Rezoning Application: PD 23-0785

Zoning Hearing Master Date: February 20, 2024

Development Services Department

The applicant requests to rezone property zoned PD (Planned Development) #85-0317 to PD #23-0785 to develop a 536 unit multi-family project.

8.0 PROPOSED SITE PLAN (FULL)

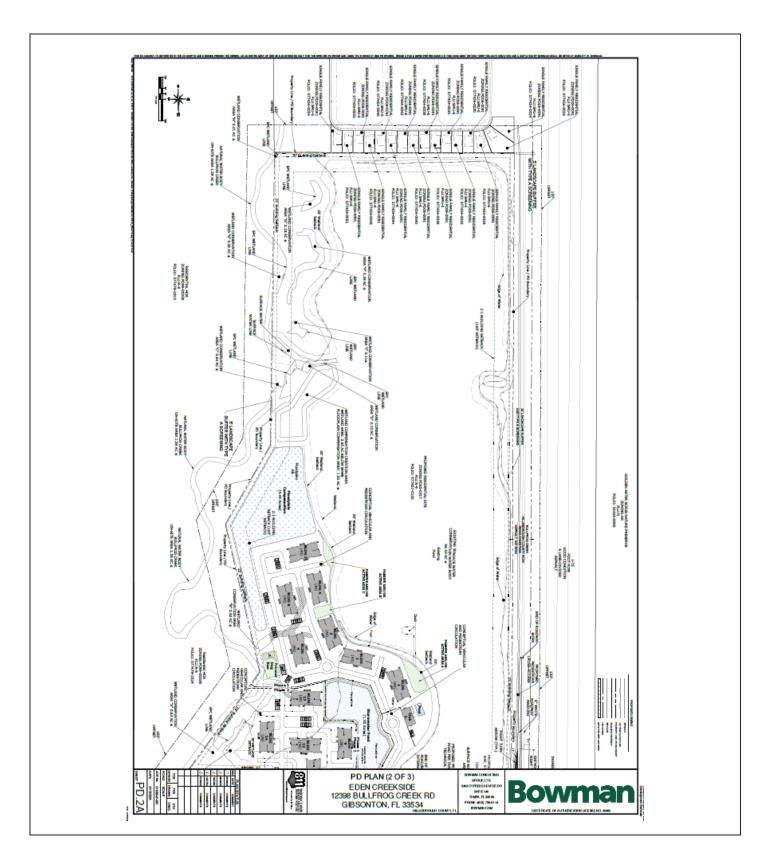
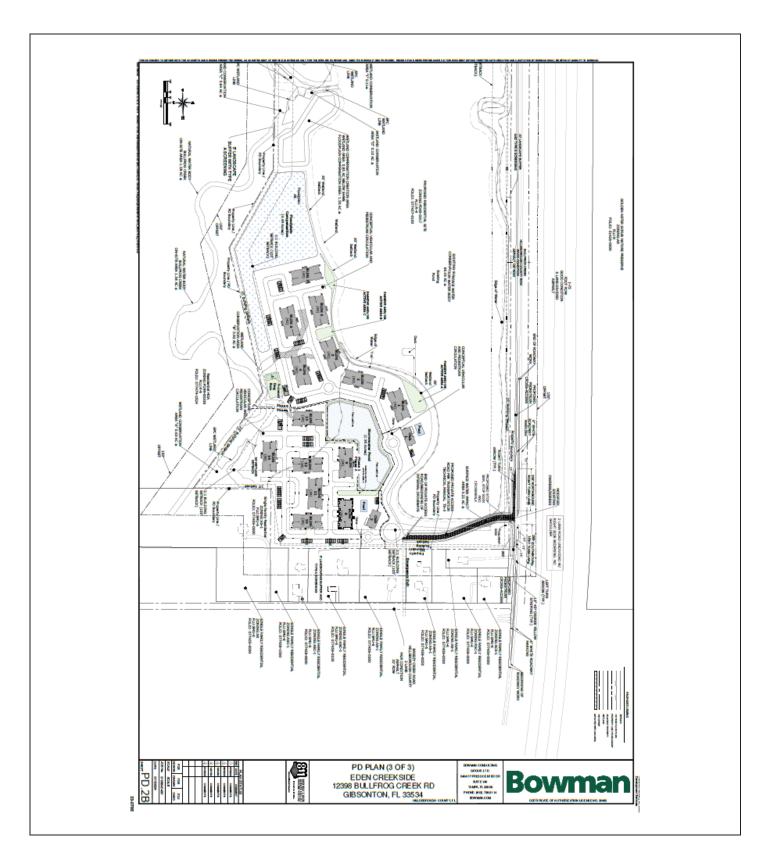
1) The developer shall revise the PD site plan to:

- a) Revise the general statement to reflect correct proposed unit count (it conflicts with the site data table on the same page);
- b) Remove all references to proposed signage (staff notes that signage must be reviewed and permitted separately in accordance with applicable rules and regulations);

- c) Revise General Note 1 to describe the internal roadway as well as the driveways (consistent with proposed condition 4, above).
- d) Correct existing/proposed sidewalk placement. Staff notes that sidewalk just south of the proposed project is located immediately +/- 2-feet west of the existing right-of-way boundary (see photo below), which is inconsistent with how its drawn on the PD site plan. Also, proposed sidewalk should be located consistent with the conditions proposed hereinabove.

- e) Revise note 10 to add to the end of the sentence ", subject to compliance with the Design Exception and conditions of zoning approval."
- 2) Site plan to be modified to comply with condition #3.

FIGURE 1 SIDEWALK IMPROVEMEN#3-0785

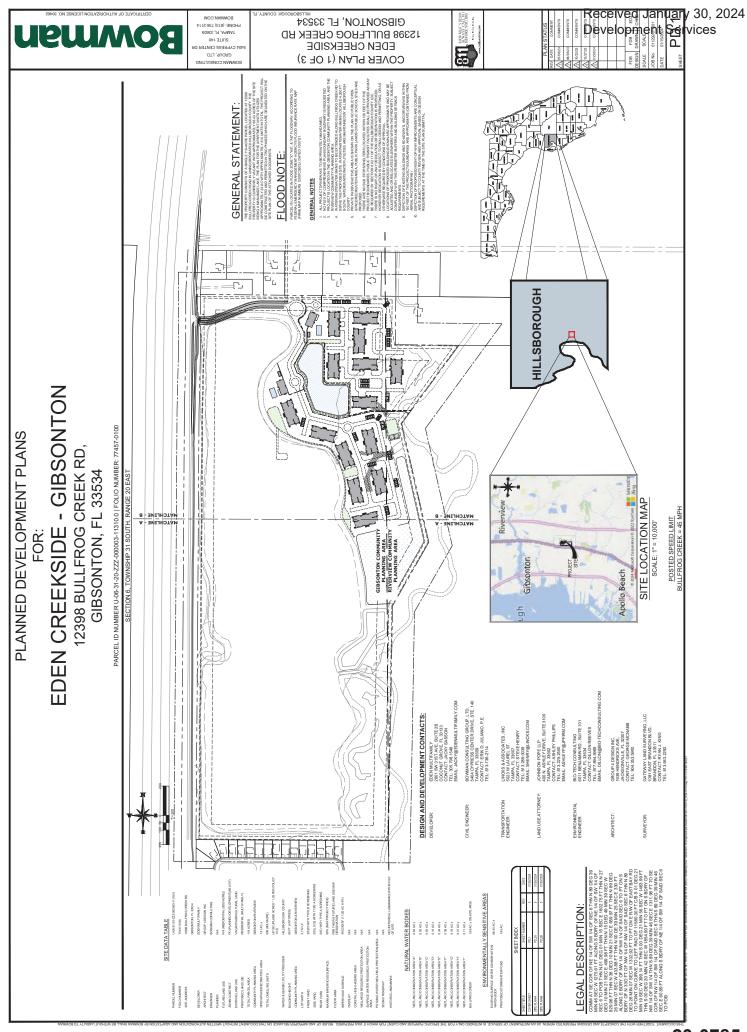
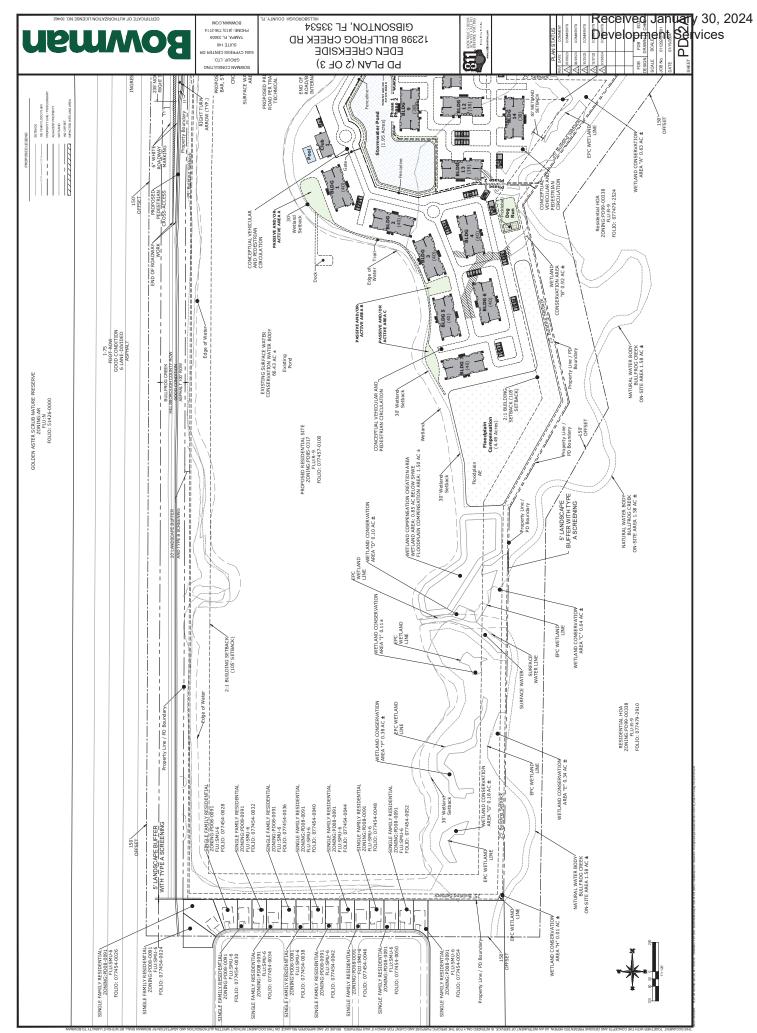
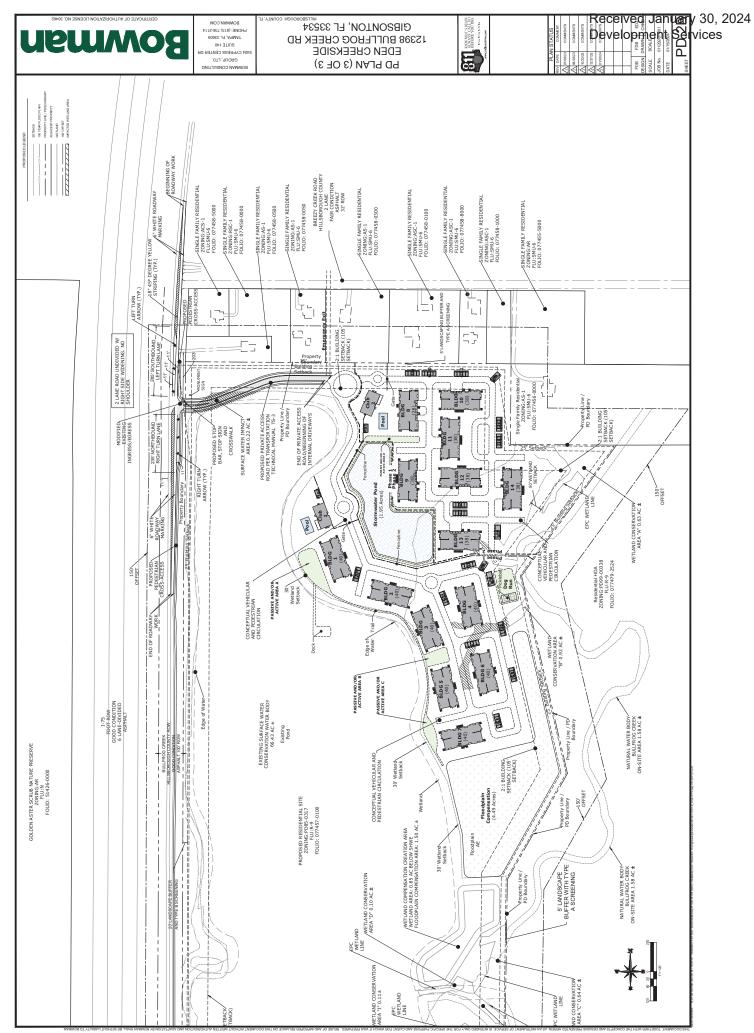
- Sidewalk the developer proposes to construct a sidewalk along the east side of the road to provide a continuous sidewalk from the project to the Vance V. Vogel Park. The developer is to construct approximately 4,030 feet of sidewalk along the proposed frontage and then an additional 1,545 feet to fill in the missing segments.
- 2. The County has plans for a 12 foot trail on the west side of Bullfrog Creek Road. This will allow bike and pedestrian circulation to the park, YMCA and schools in the area.
- 3. The developer proposed to construct the access improvements along Bullfrog Creek Road with an east side widening that will then allow the planned trail on the west side of Bullfrog Creek Road.

Figure 1 illustrates the proposed sidewalk improvements. With these improvements there will be a continuous sidewalk from the project access to the park entrance.

8.0 PROPOSED SITE PLAN (FULL)

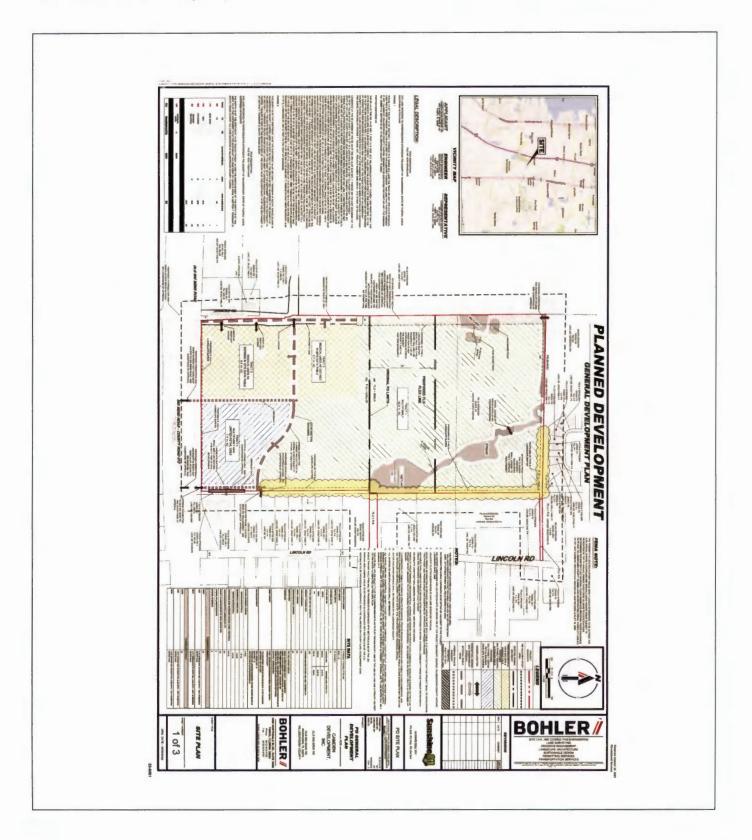
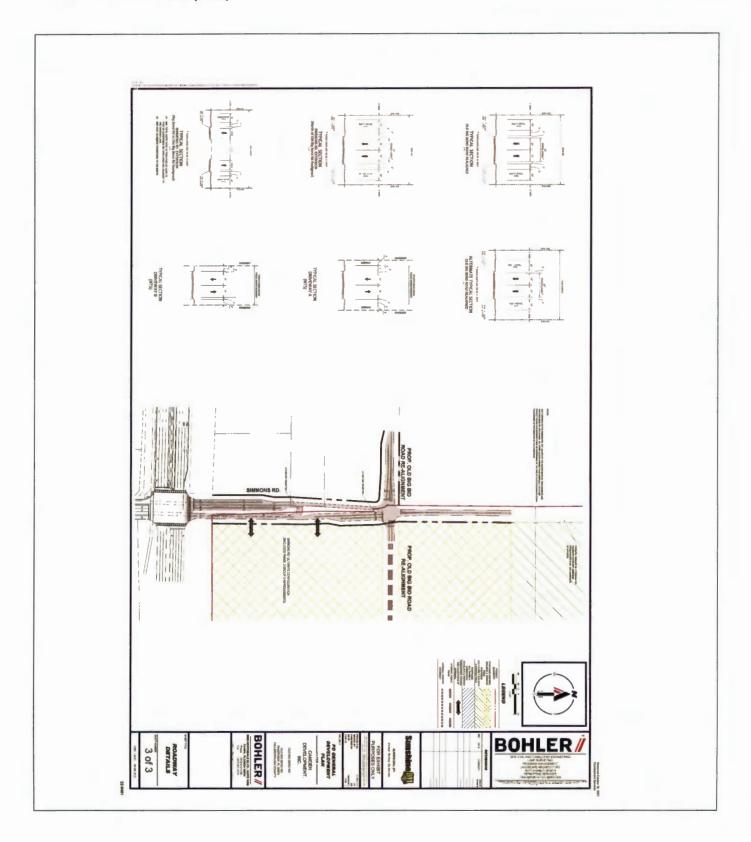
- 8. Modify the "Driveway B" Typical Section on Sheet 3 of 3 to add minimum 5-foot wide sidewalks on both sides of the roadway, separated from the back of curb by 5-foot wide green strips. Add a footnote applying to the sidewalk on the east side of the roadway. Footnote shall state "The sidewalk along east side of road is optional; however, such sidewalk shall be constructed together with any vehicular access constructed within the "Potential Access Area" as shown on Sheet 1 of PD site plan (i.e. the optional access to/across folio 77550.0000)."

- 9. On Sheet 2 of 3, replace the three (3) references stating "By the 22-0461 Developer" to instead state "By the Developer of the Subject PD".
- 10. For all Typical Sections on Sheet 3 of 3, ensure all individual components are labeled. For example, label the 5-foot wide and 1-foot wide areas as "Grass Strip". On the "Driveway A" and "Driveway B" Typical Sections, ensure that it is labeled as "Type F curb and gutter".

- 11. On Sheet 3 of 3, please ensure label stating "Simmons Rd. Ultimate Configuration (Includes Phase 2 Group 2 Improvements)" is prominently shown. It should appear either at the top or bottom of the graphic. Consider placing it above the note near the top left corner of the graphic, with a bold font that is at least as large as the other text in the graphic.

- 12. On Sheet 2 of 3, add to the "Phase 2 Improvements (Group 2)" list a new item stating "Developer or others to construct eastbound to northbound left turn lane on realigned Old Big Bend Rd. onto Lincoln Rd."

- 13. On Sheet 2 of 3, modify note 4 and 5 within the "Phase 1 Improvements" list. These incorrectly state these will be constructed to the Type TS-3 non-residential standard. Replace instances stating "Roadway" with "Driveway" within the first two sentences. Replace the last sentence with a sentence stating "Developer to construct to the Typical Section standard shown on Sheet 3 of 3."

- 14. On Sheet 2 of 3, add to the "Phase 2 Improvements (Group 1)" list a new item stating, "Developer to construct a transit bus bay, shelter and amenities see zoning conditions."

- 15. On Sheet 1 of 3, modify the graphic depiction of the potential access area bounding box such that its southernmost extent runs to the limits of the southern PD boundary.
